PROJECT	Brickline Greenway North Connector – Phase 2	ADDENDUM NUMBER	01
PROJECT NO.	14654 (GRG 308s)	DATE	9/1/2026
PROJECT LOCATION	St Louis, Missouri		
CLIENT	Great Rivers Greenway		
PREPARED BY	Hannah Higgins, SmithGroup

ADDENDUM #01

Proposed changes include the following updates and the related pay item, bid tab, and JSP adjustments required:

CS7-105

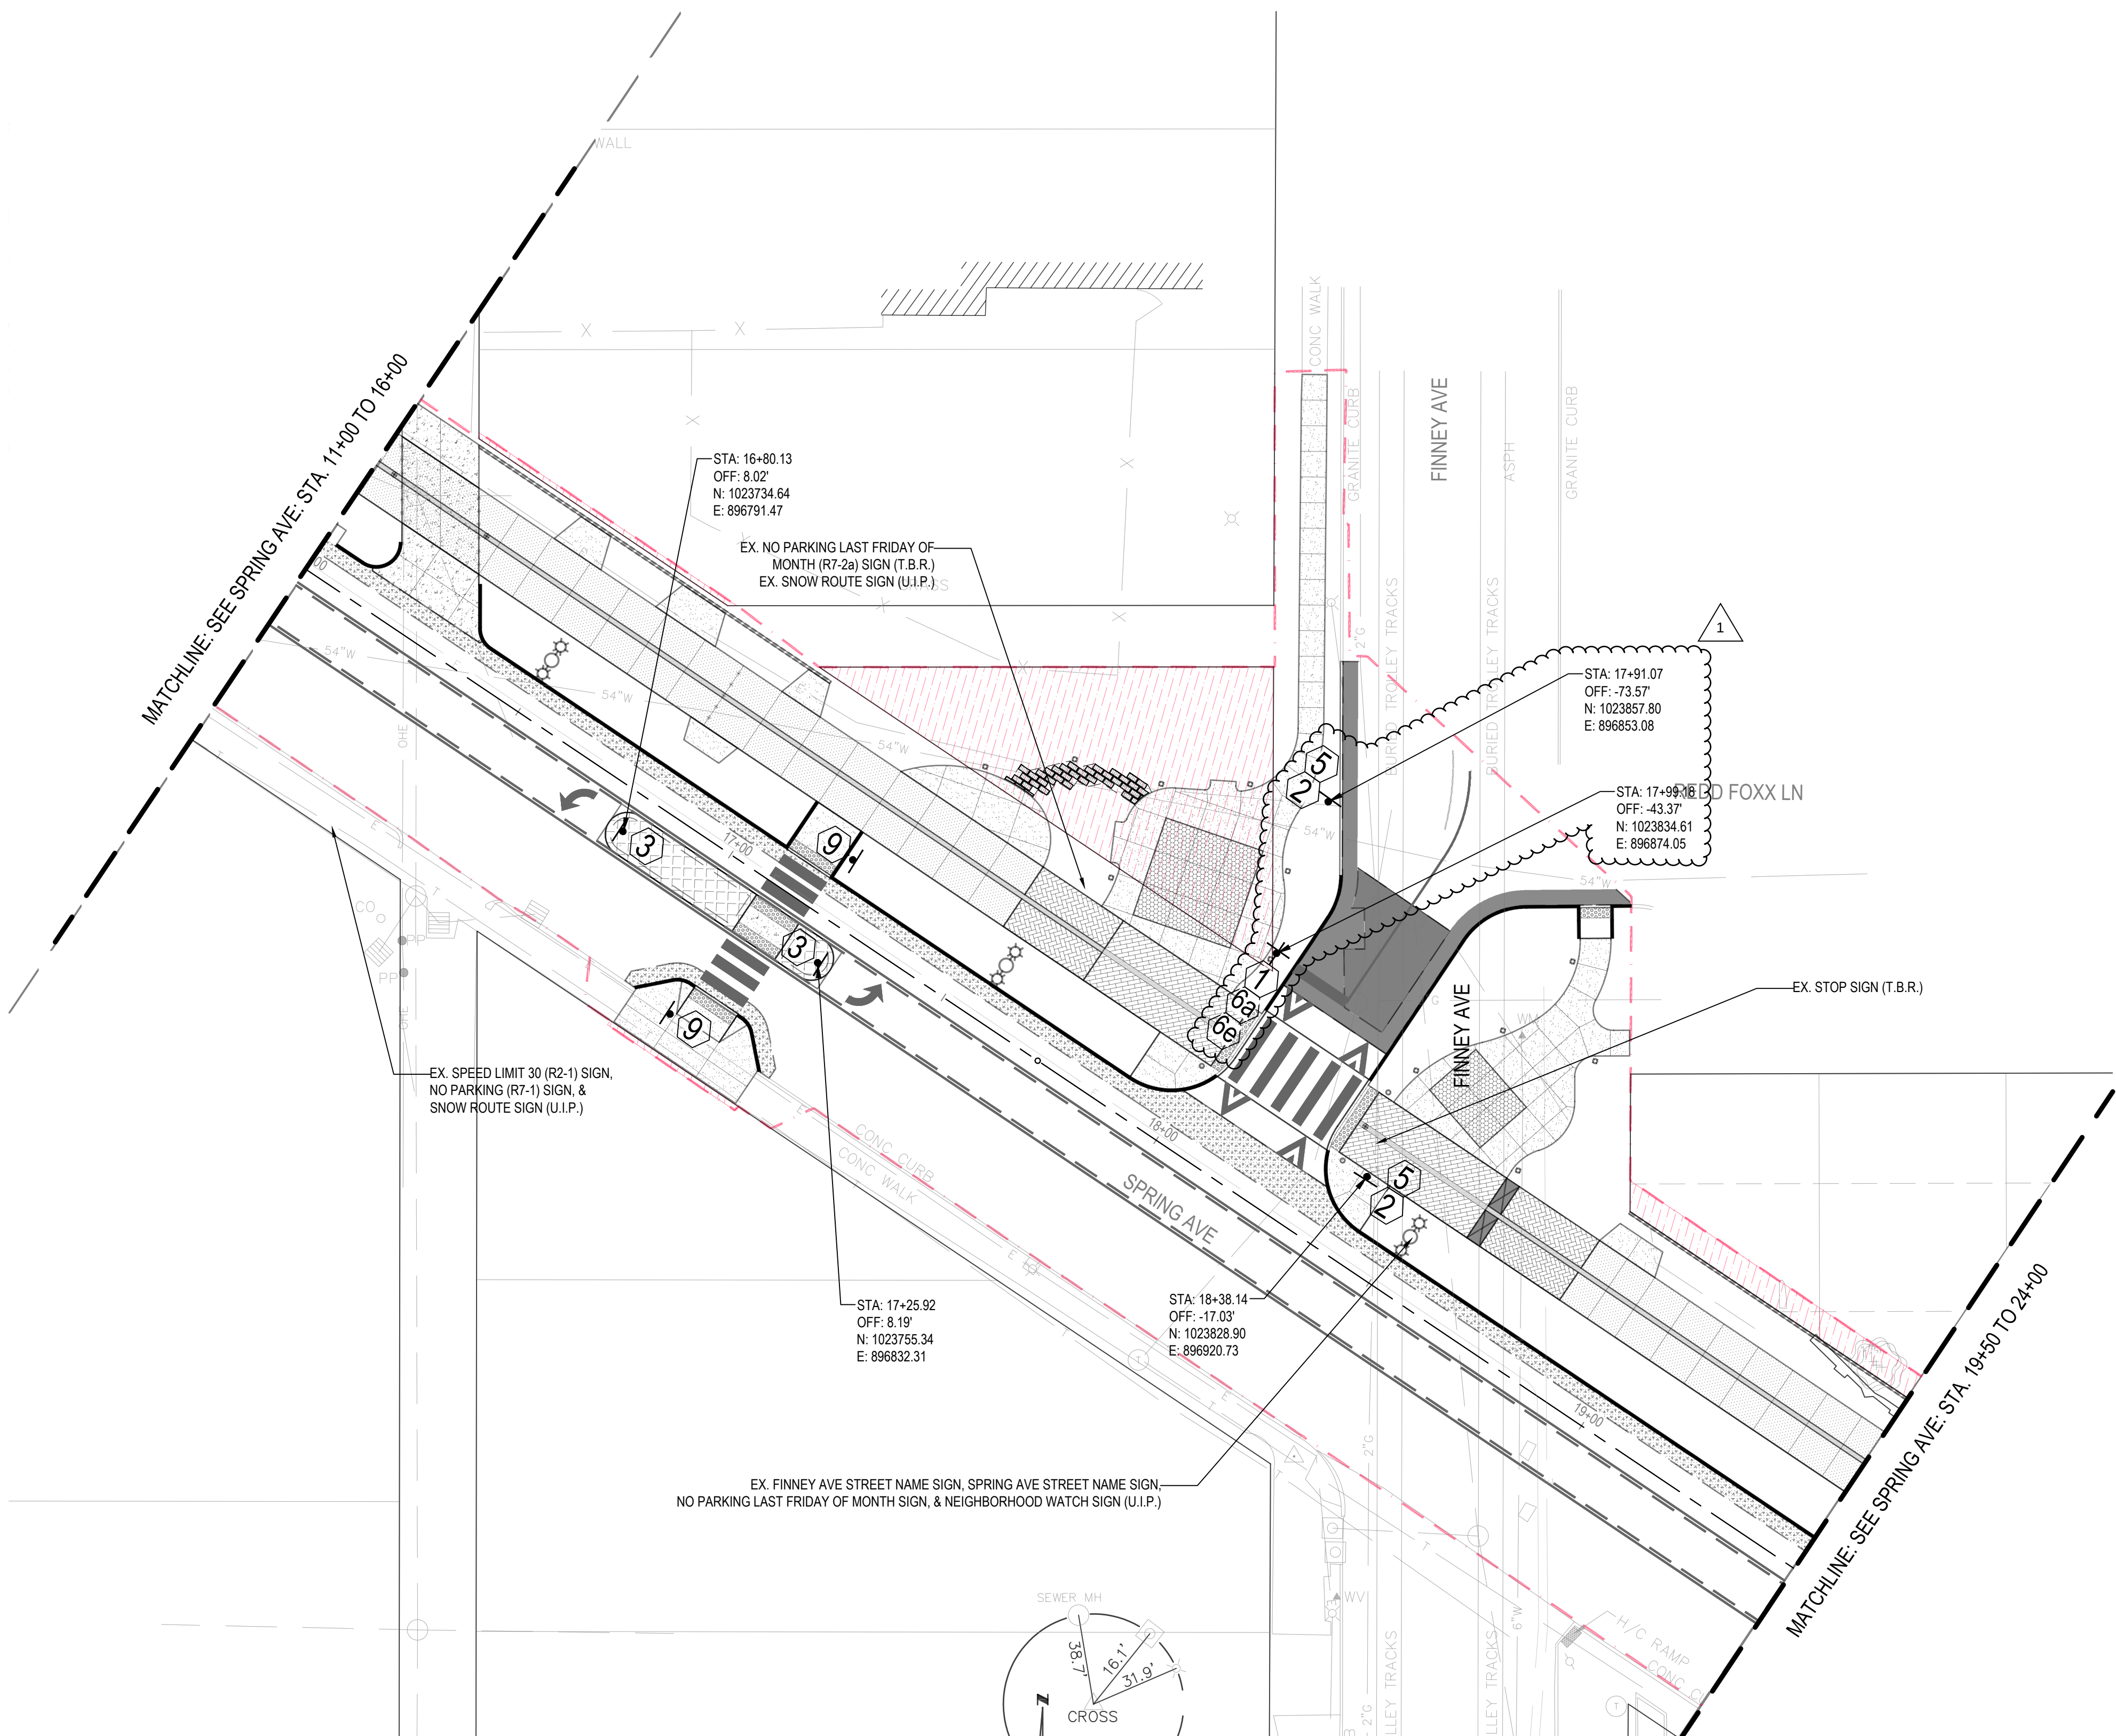
- P. CS7-105 REGULATORY SIGNAGE PLANS – SPRING – AREA 5: Updated two sign locations at Spring/Finney intersection.
- Q. CS7-501 REGULATORY SIGNAGE DETAILS: Signing Schedule: signs updated at Spring/Finney intersection.

L1-105

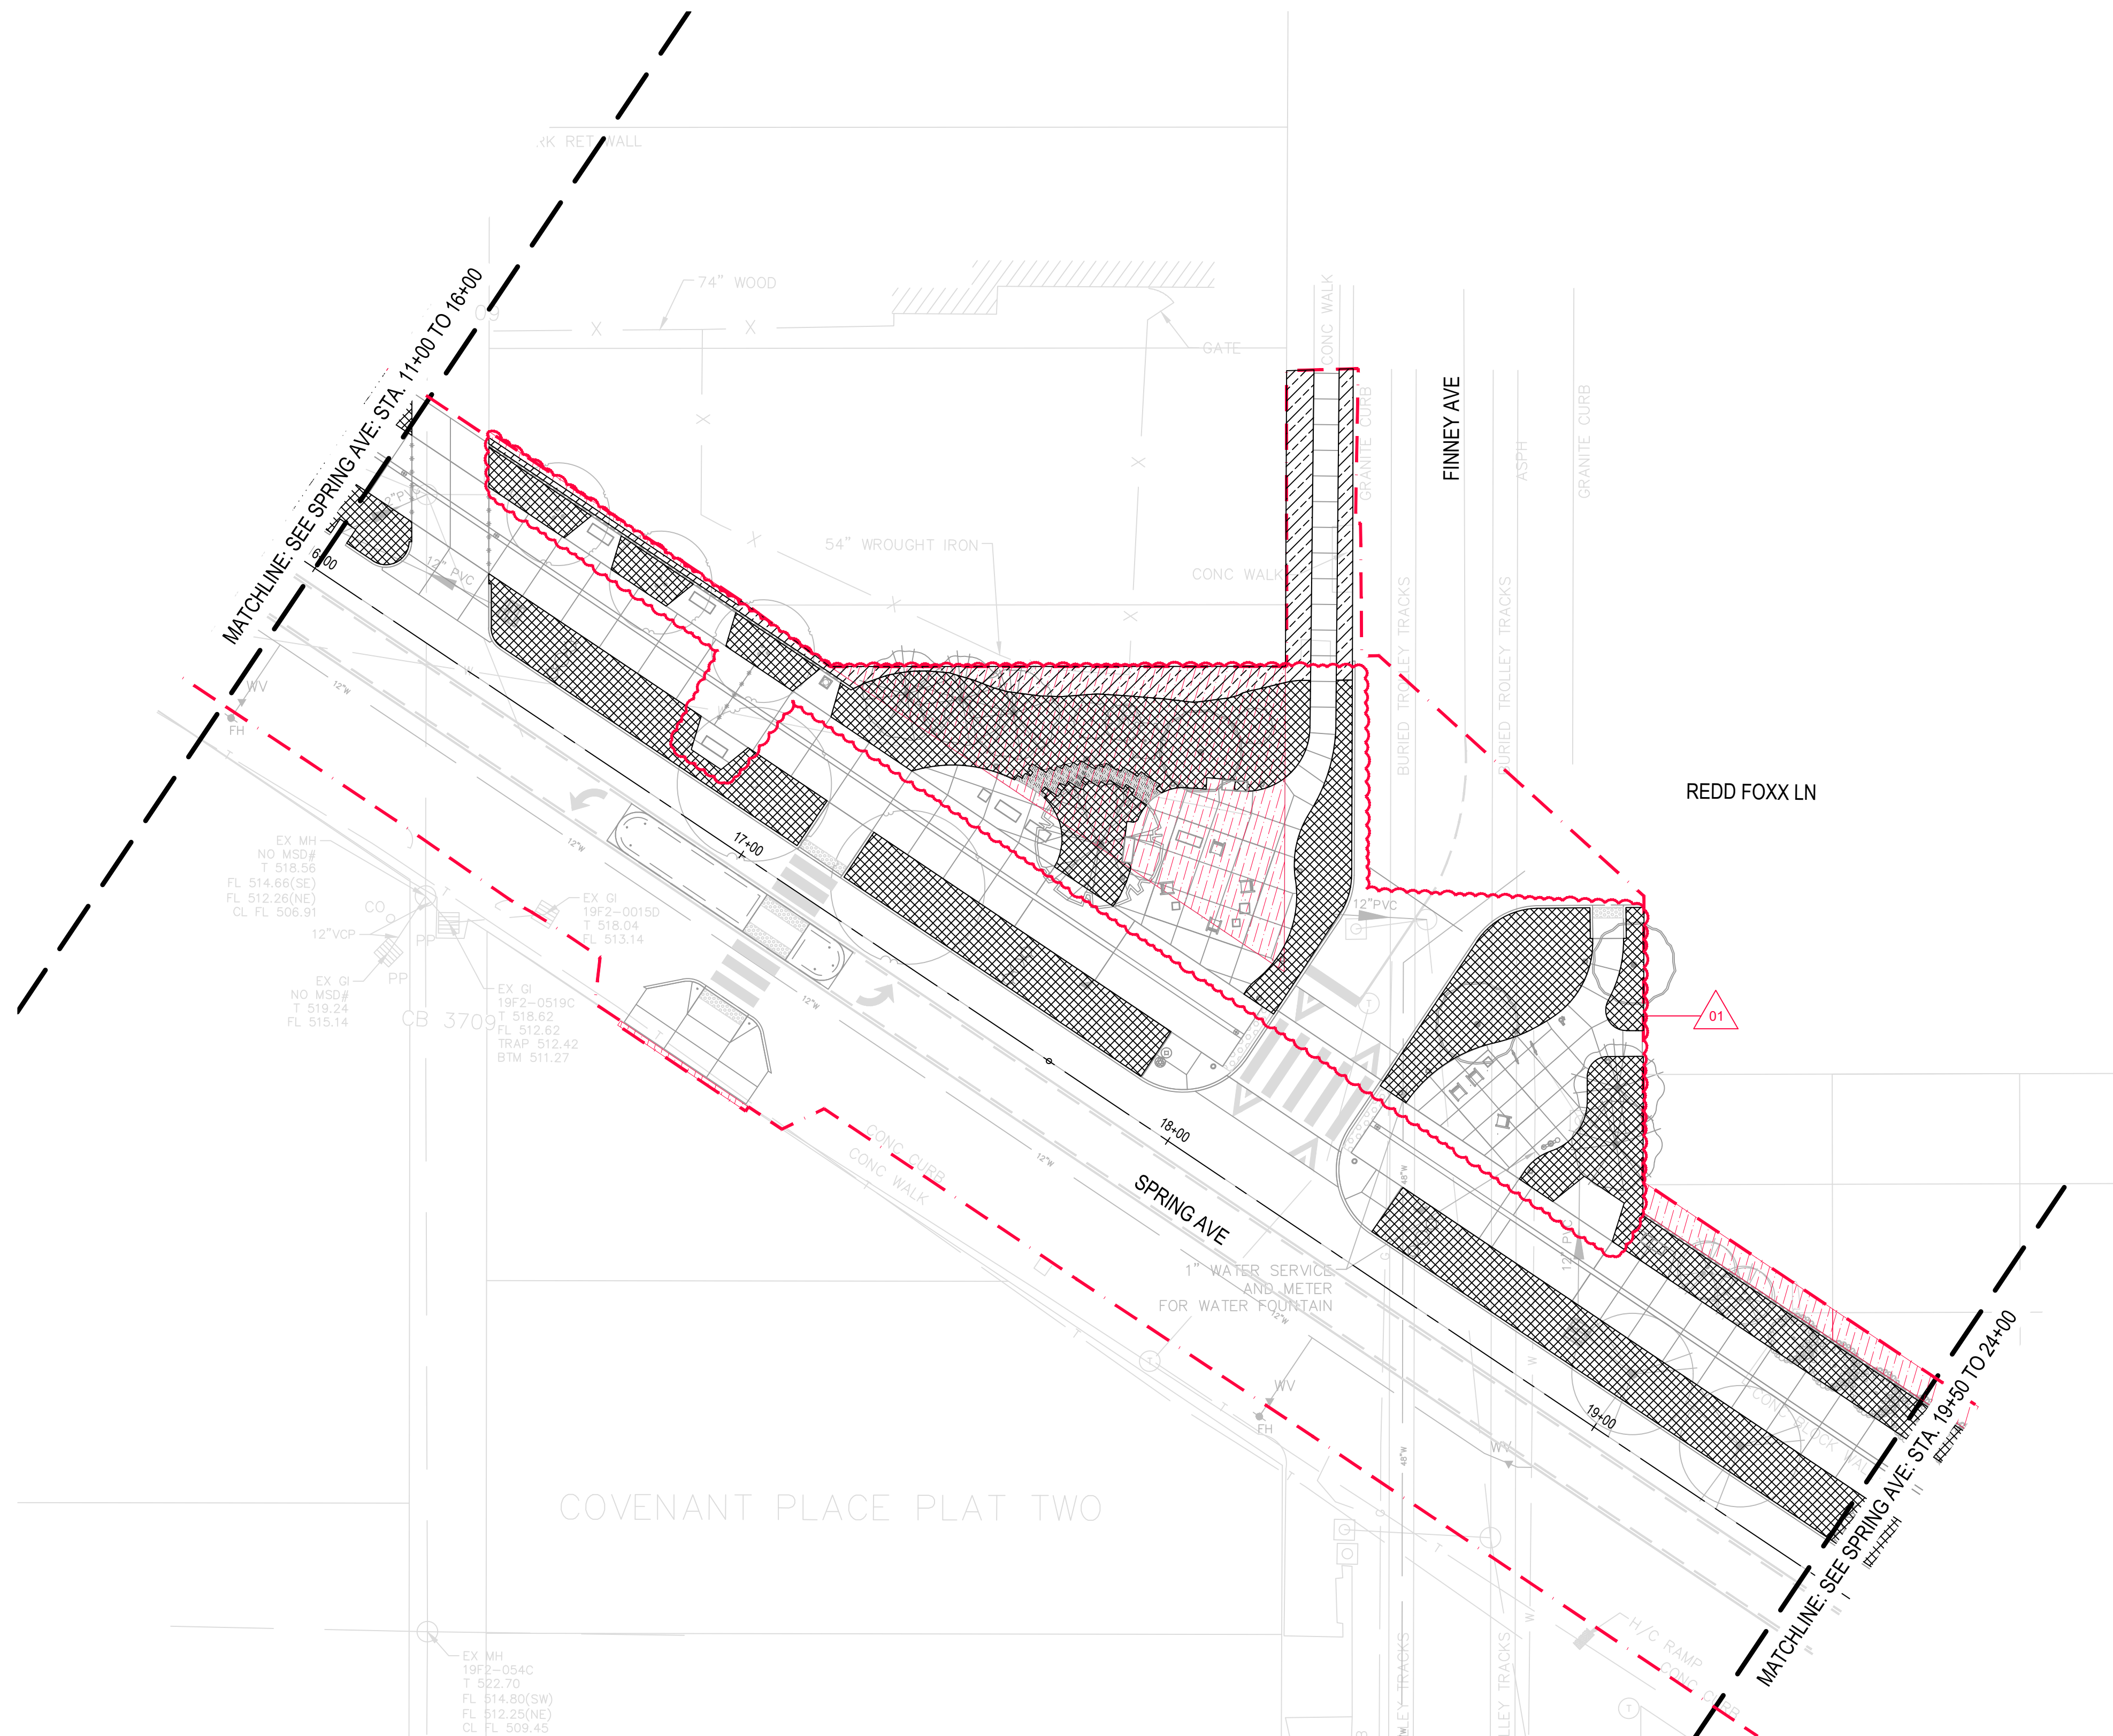
- R. L1-105 SOILS PLAN - SPRING - AREA 5: Updated planting soil extents at Spring/Finney intersection.
- S. L1-107 SOILS PLAN - SPRING - AREA 7: Updated planting soil extents for additional trail signage pavement.

L4-105

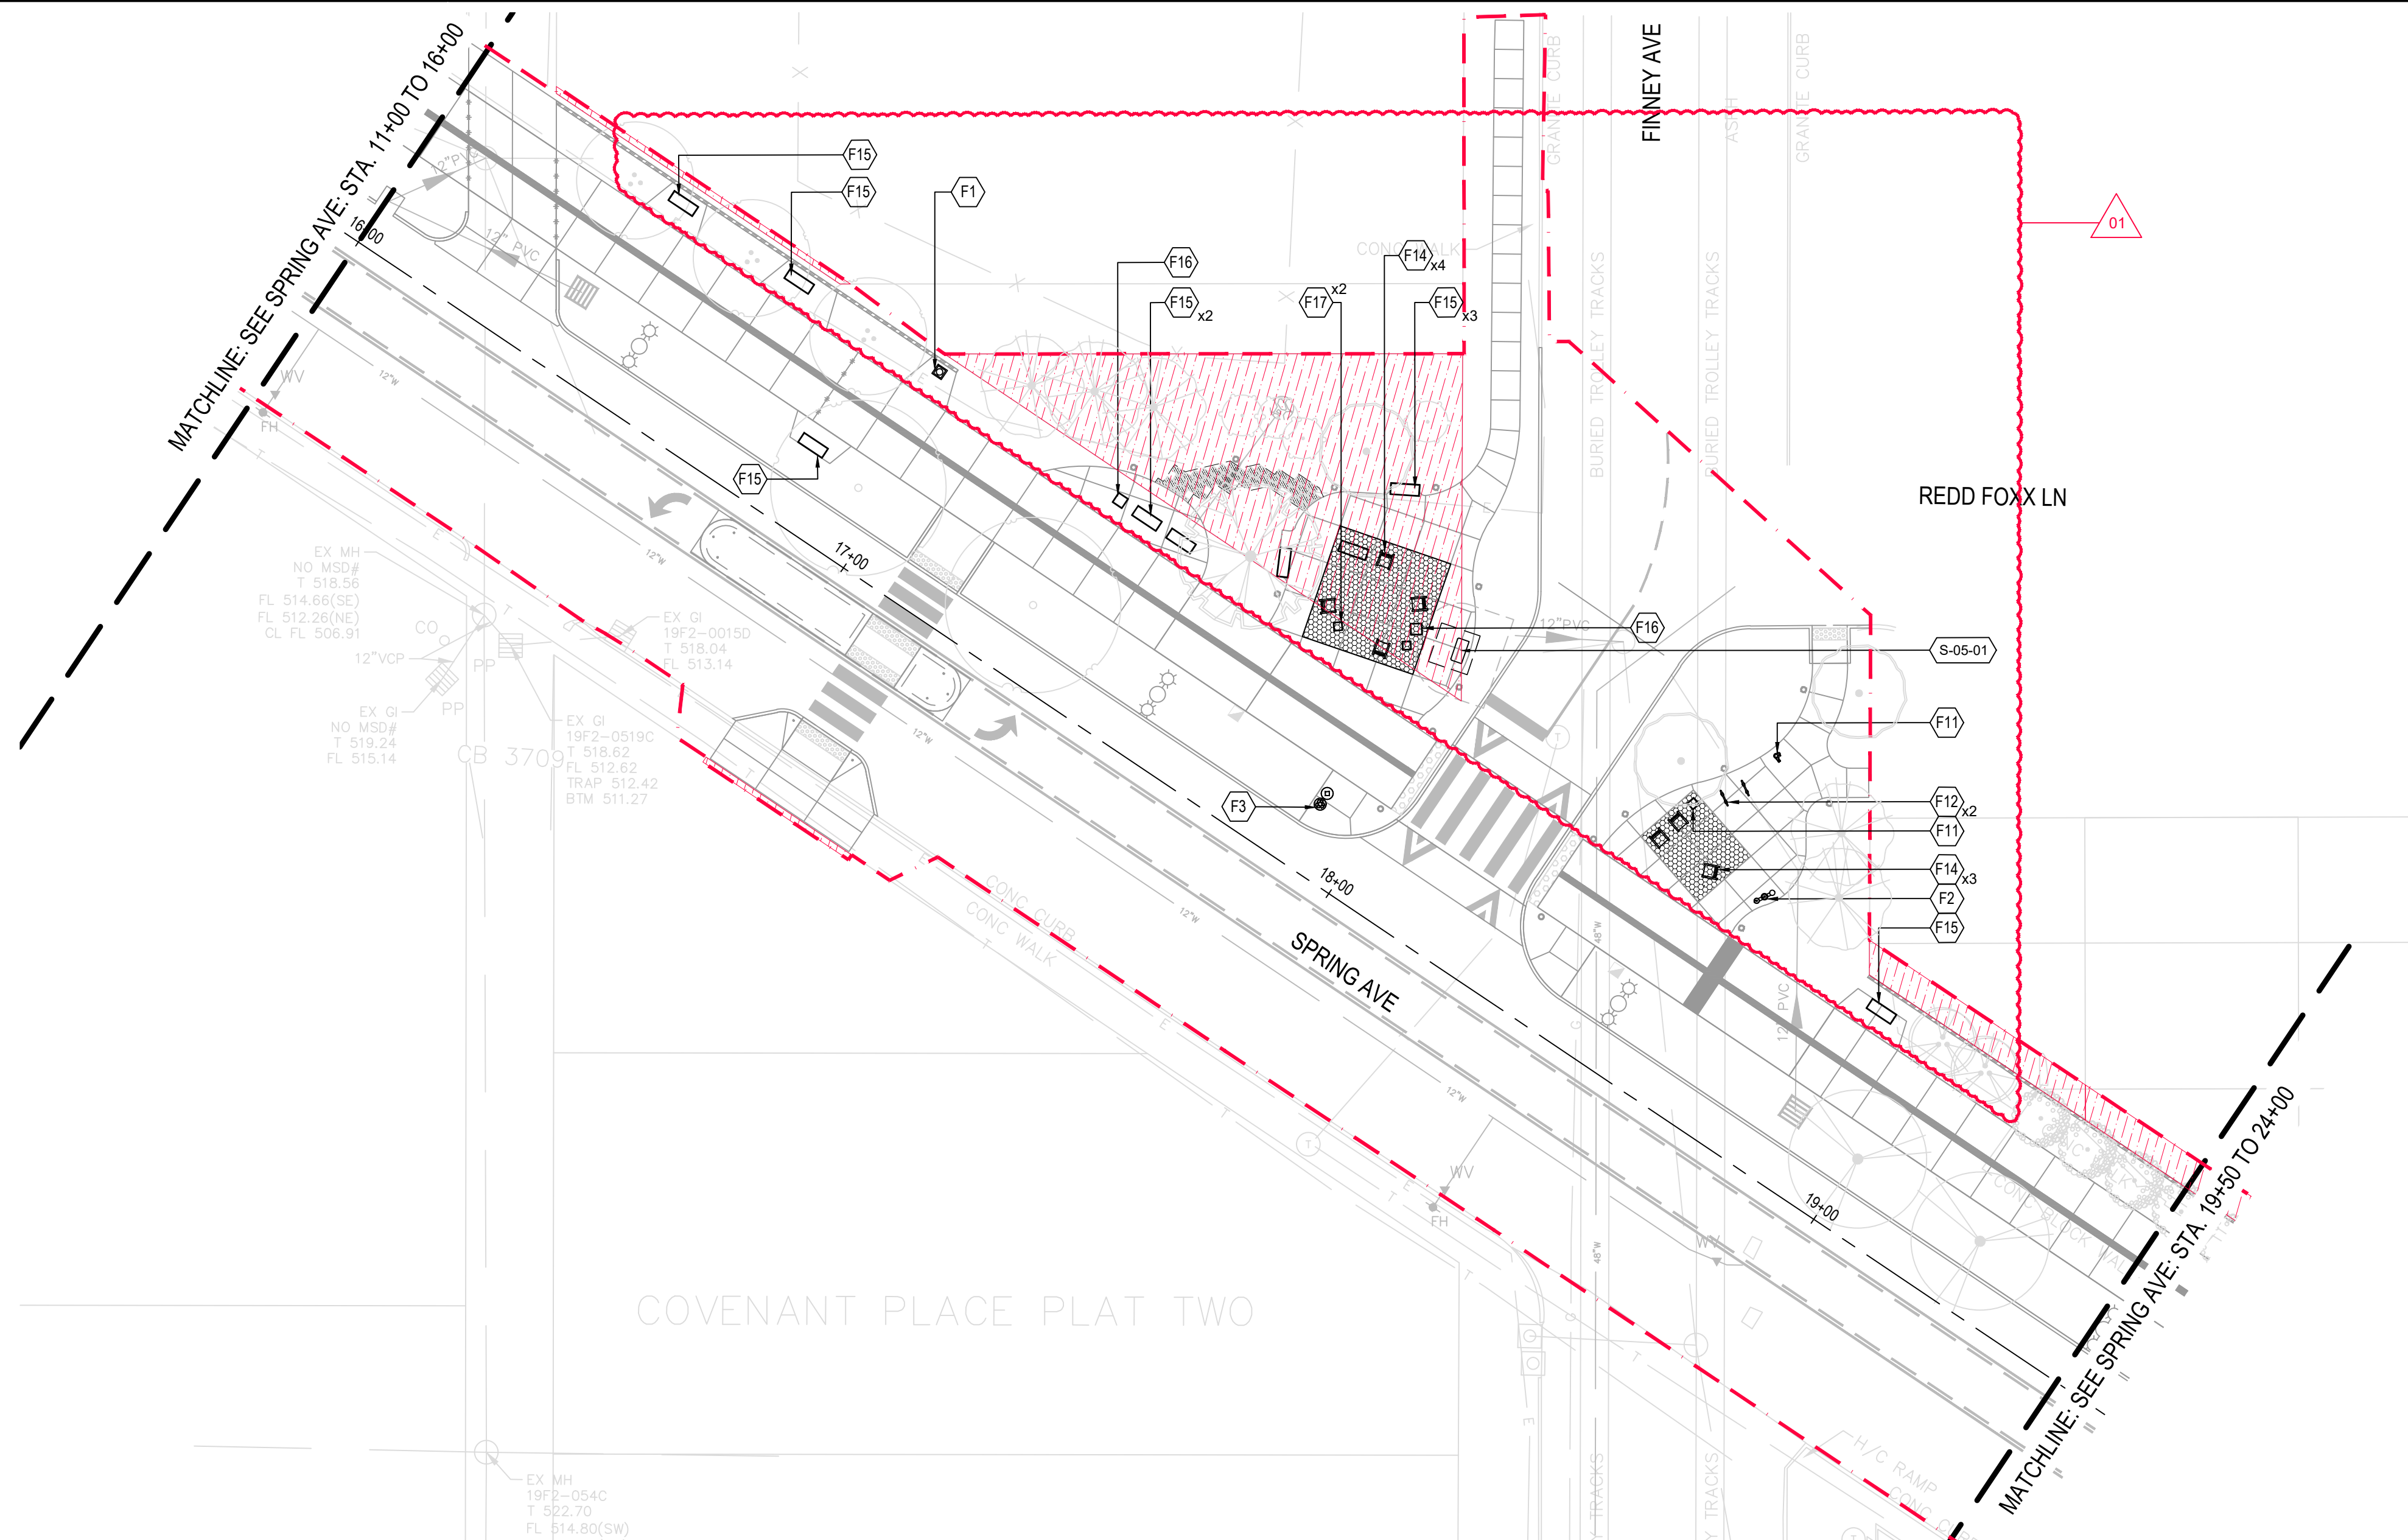
BB.L4-105 TRAIL SIGNAGE AND FURNISHINGS PLAN - SPRING - AREA 5: Updated Sheet Legend and Signage Schedule. Updated Furnishings and Signage Tags. New Furnishings include:
